INTERNET
CAFE

SECTION AT ATM LOCATION 1:50

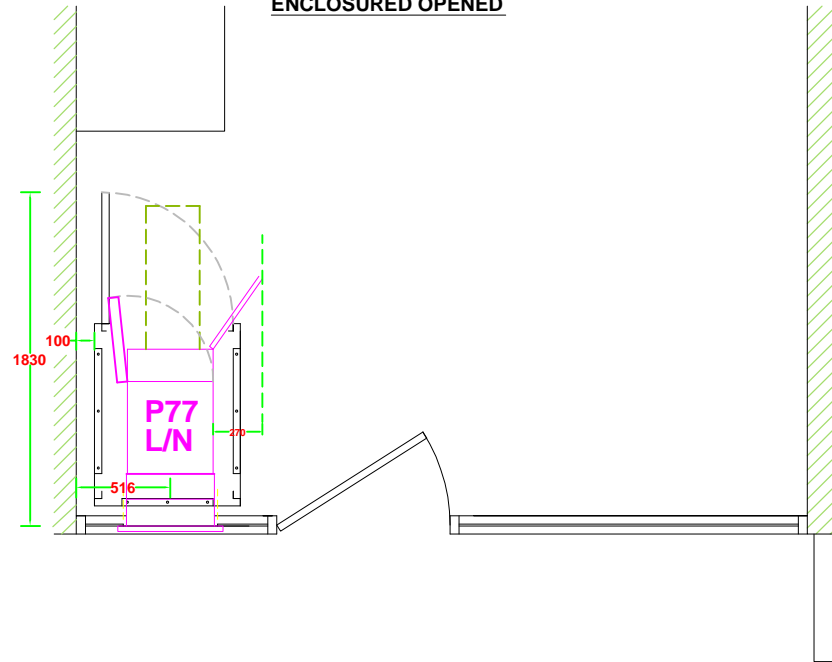
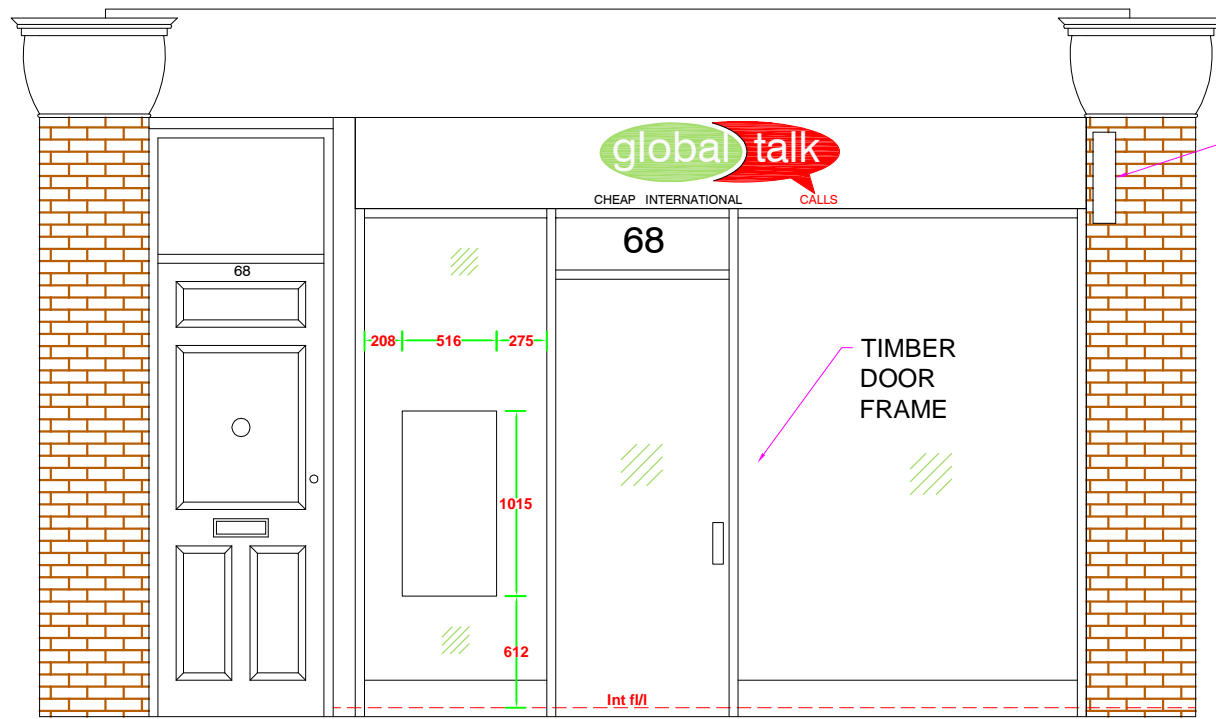
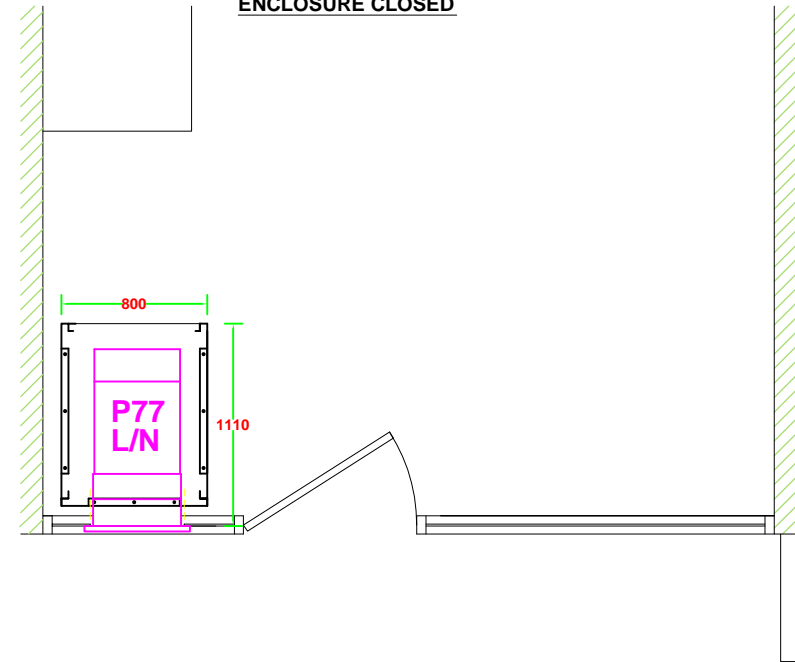
**CTS WOULD RECOMEND 10.8 LAMINATED GLAZING TO BE INSTALLED
APERTURE TO BE 516mm WIDE x 1015mm HIGH - MUST BE 612mm FROM INSIDE FLOOR LEVEL TO BOTTOM OF APERTURE
NO ATM SIGNAGE TO BE INSTALLED (DUE TO PLANNING REFUSAL)**
